NUMBER: 08-100-14

Loss Of Power Heated Mirror Function - Recall P61 Interim Repair

2011 - 2013 (JK) Jeep Wrangler

Fig. 1 Totally Integrated Power Module

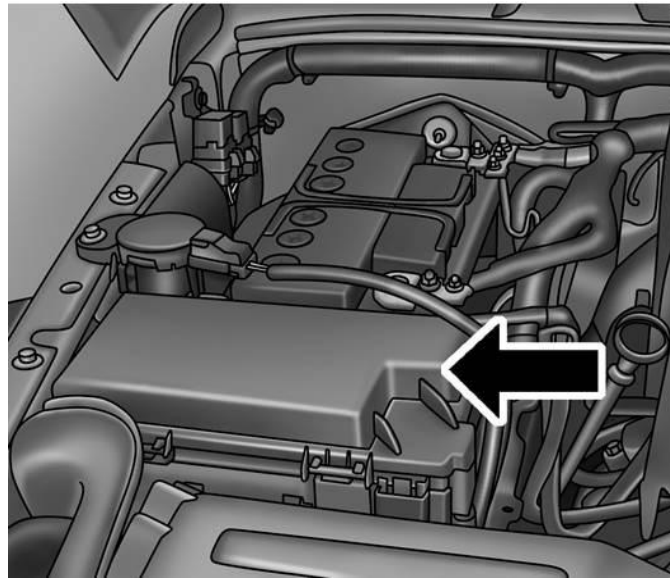
In the meantime, if the customer is uncomfortable with the current situation, remove the 10 amp red M35 heated mirrors fuse from the totally integrated power module (TIPM)([Fig. 1](#)). Refer to the fuse location printed on the back side of the TIPM cover.
